# HISTORIC LANDMARK COMMISSION STAFF REPORT

**Wright Major Alteration**  
PLNHLC2013-00744  
Avenues Historic District  
1204 First Avenue  
November 7, 2013

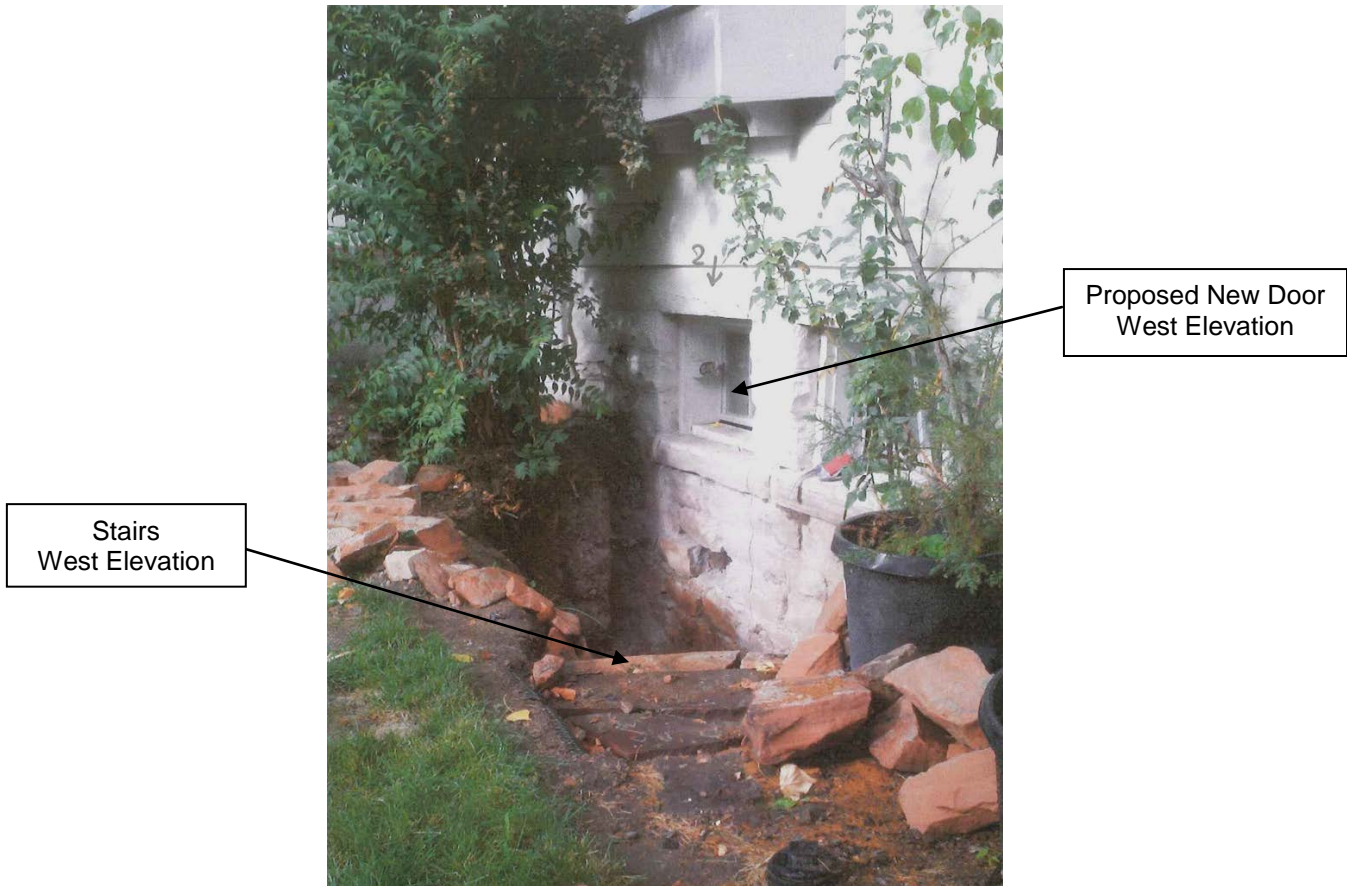
A new window opening on the basement of the west elevation, or the front façade, was created without approvals or permits. According to the property owner, the purpose for the new window is to create required egress to a new bedroom in the basement. As such, the window needs to be at least 5.7 square feet and it needs to be 44" from the floor to the opening. The opening for the new window is 24" wide and 42" tall. The opening that was created meets the requirements for building code with regard to egress. It exceeds the requirement by 1.3 square feet.

**Analysis:** The proposed window on the west elevation, (or front façade) and south elevation fail to match the original windows in design and other visual qualities.

The opening for the new window is 24” wide and 42” tall. There are two original basement windows on the west elevation; they are approximately 33” wide and 24” tall. The proposed window for the west elevation is a Jeld-Wen pre-fabricated casement window with two lights horizontally and 3 lights vertically. The original windows are awning windows with three lights horizontally with a much narrower stile and rail as the proposed window. Also, the reveal on the stone work of the new window opening should match the existing reveal details.

**Findings:** In both cases the proposed windows do not match the original windows in dimension, in materials and in design. The proposed new windows detract from the character of the house.

Although Planning Staff finds that the proposed window on the west elevation does not comply with the standards of the ordinance and the guidelines in the Preservation Handbook, the new window is needed for egress. Staff finds that the window could be approved by changing the request with an opening that would be compatible with the original windows and with a custom window that would match the casing and lights of the original windows.

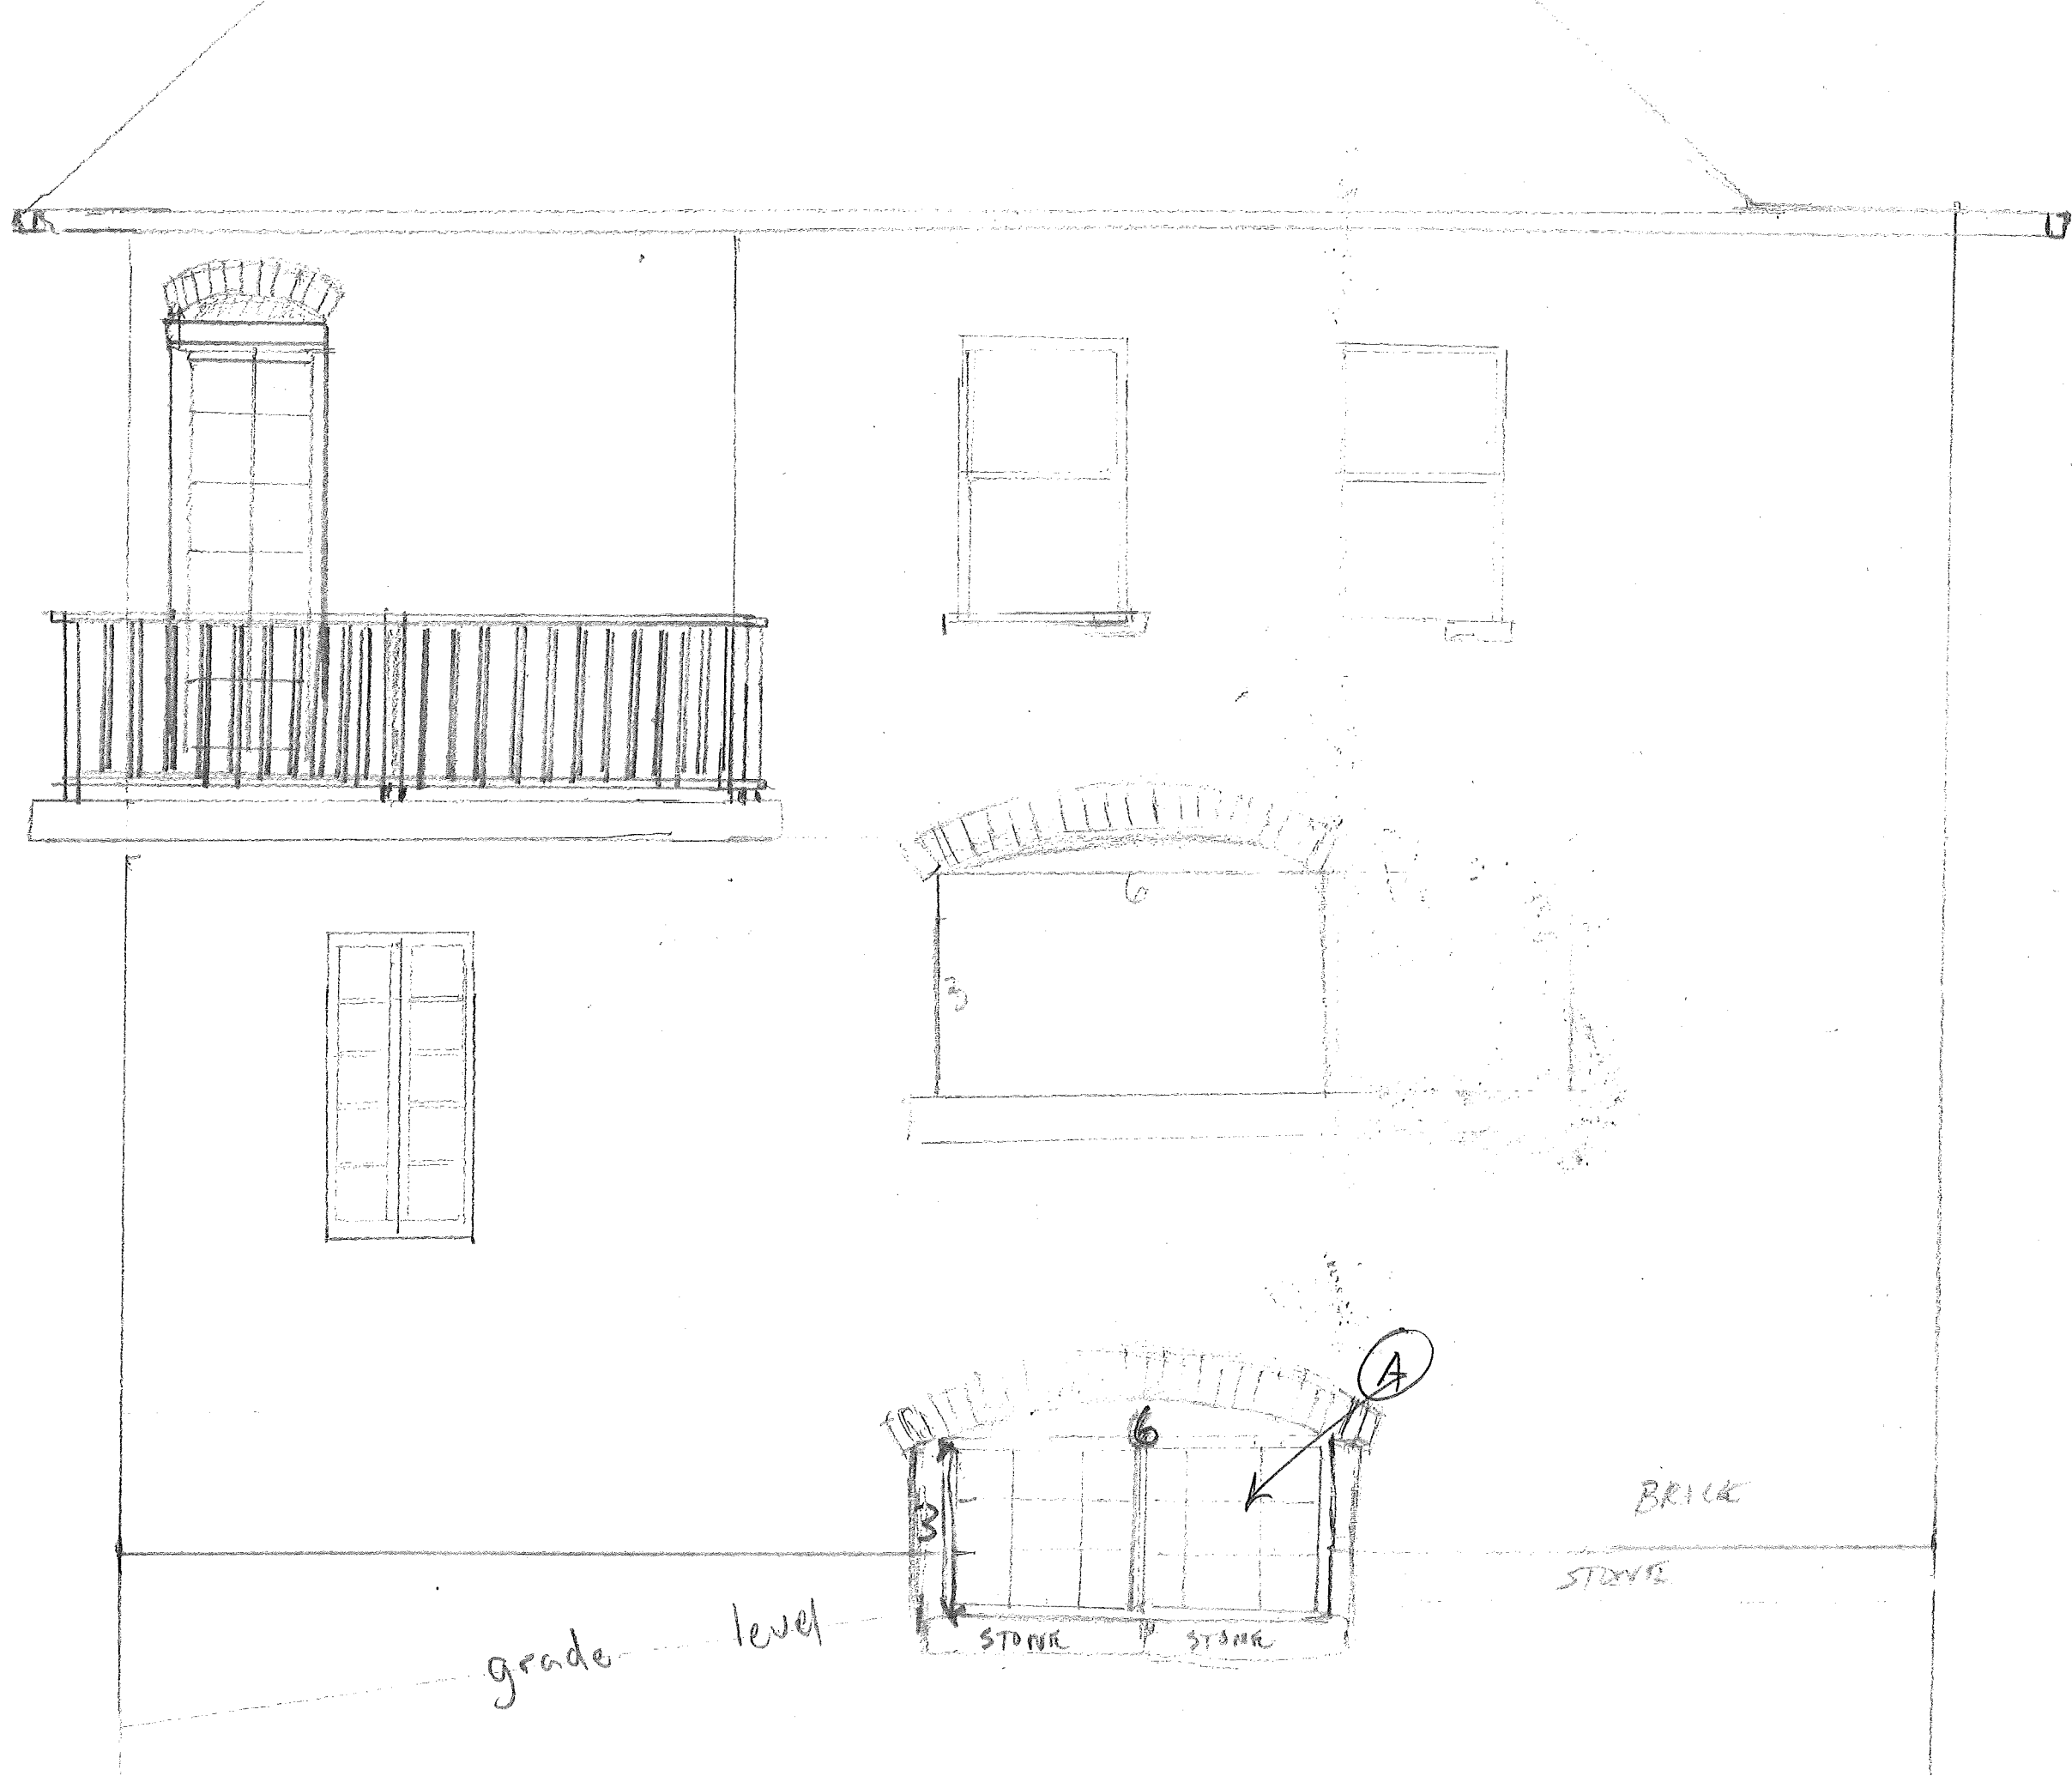
**Analysis:** The proposal is to replace one of the original windows in the basement with a 32” wide by 72” tall French style door. The top part of the door would be readily visible from the street. The design of the door does not match the original basement windows. The original windows are awning windows with three lights horizontally and with a much narrower stile and rail as the proposed door.

**Findings:** This door is inappropriate for the front façade of this contributing historic structure.

**Findings:** The proposed door and stairs are inappropriate elements for the front façade of the structure. The new window as proposed is also inappropriate.

**Stairs - West Elevation**

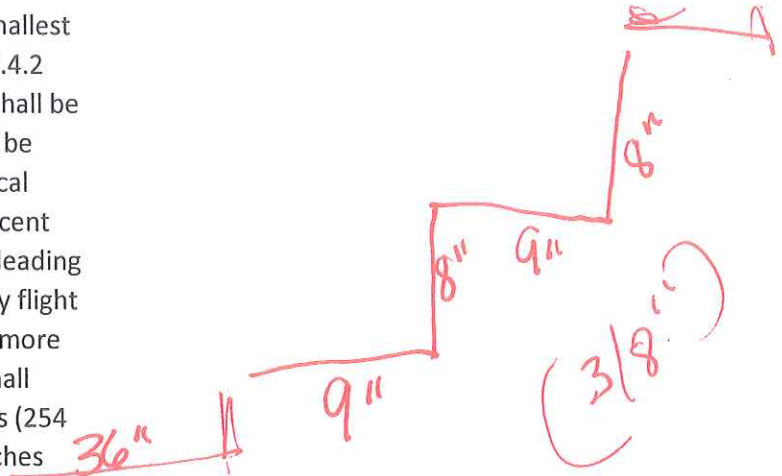
The stairs were built on the west elevation, or front yard, without approval or permit. The purpose for the stairs is to access to the proposed door. There are five stone slab steps rising from the landing. A railing/banister is being proposed. The stairs do not meet building code because the steps are uneven in height (they vary from 7 to 7.5 inches) and are not level.

**Analysis:** The work being done to the basement can be treated and evaluated similarly to that of an addition. The proposed entrance to the basement in the front yard is uncharacteristic for this neighborhood. The proposed rear yard window, the proposed door to replace an existing window, and the new stairs are elements that substantially alter the character of this historically contributing structure.

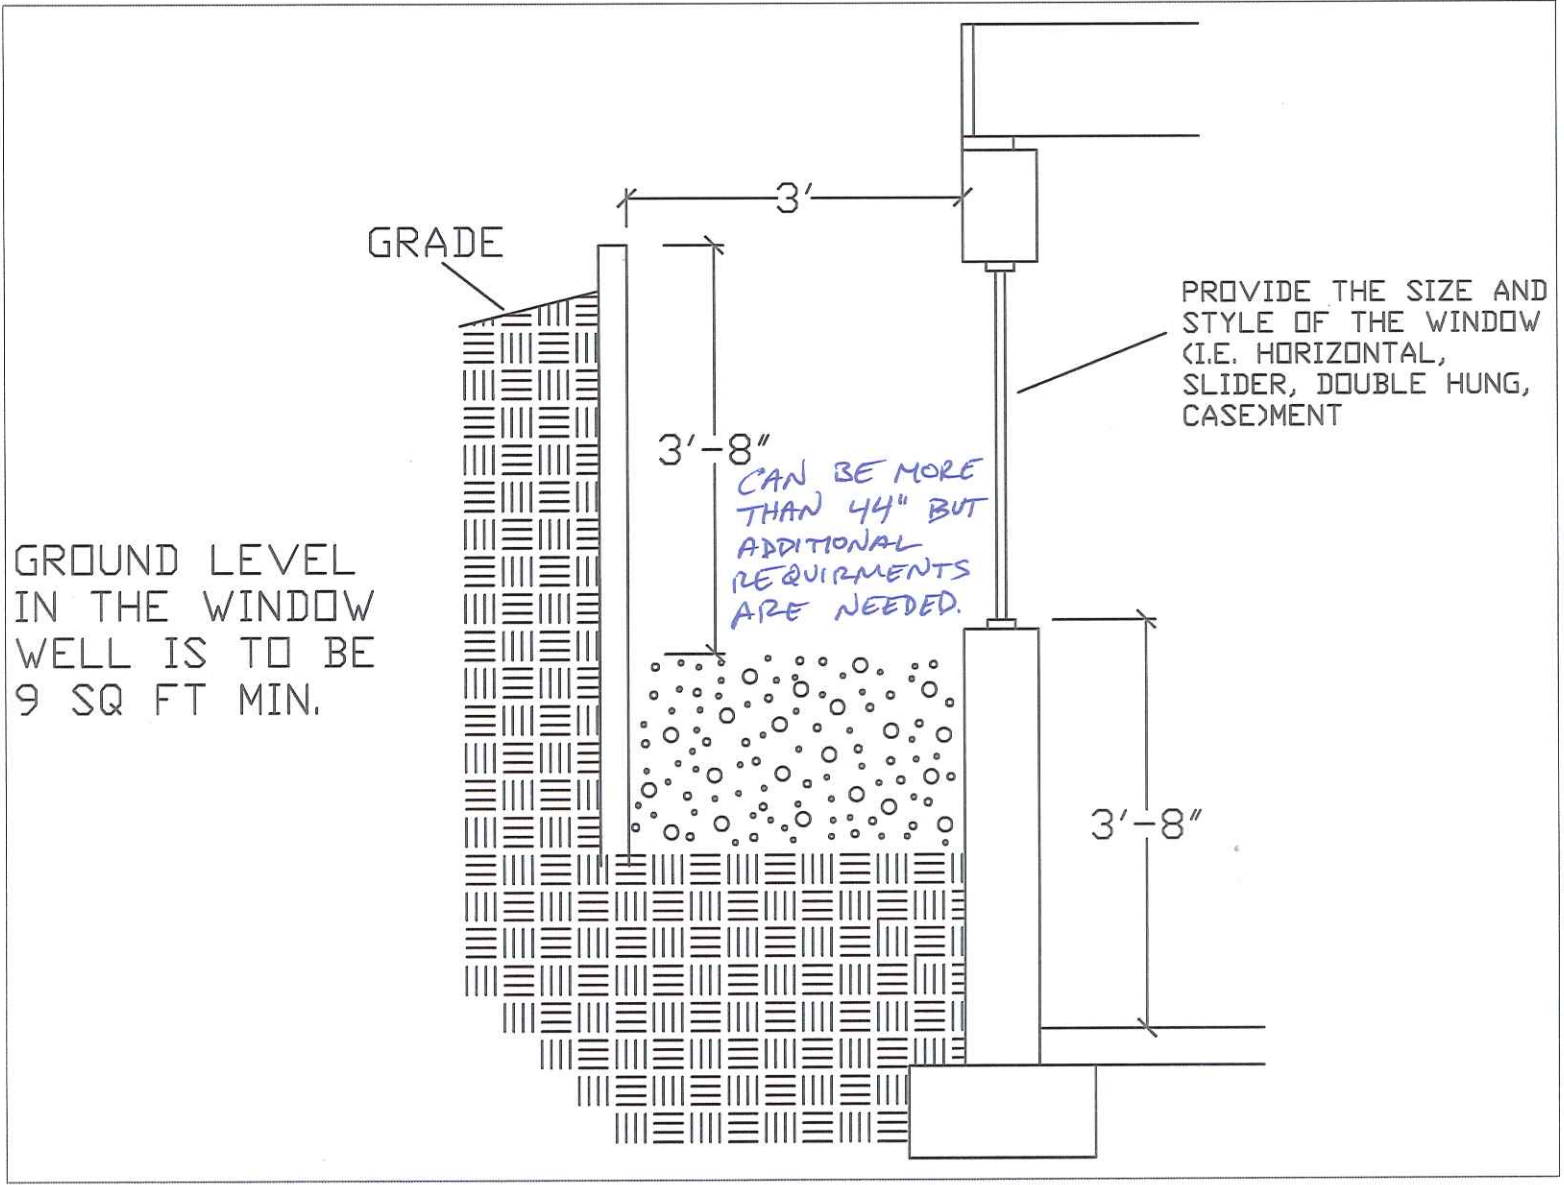
3'-8"  
CAN BE MORE  
THAN 44" BUT  
ADDITIONAL  
REQUIRMENTS  
ARE NEEDED.

PROVIDE THE SIZE AND  
STYLE OF THE WINDOW  
(I.E. HORIZONTAL,  
SLIDER, DOUBLE HUNG,  
CASEMENT)

GROUND LEVEL  
IN THE WINDOW  
WELL IS TO BE  
9 SQ FT MIN.
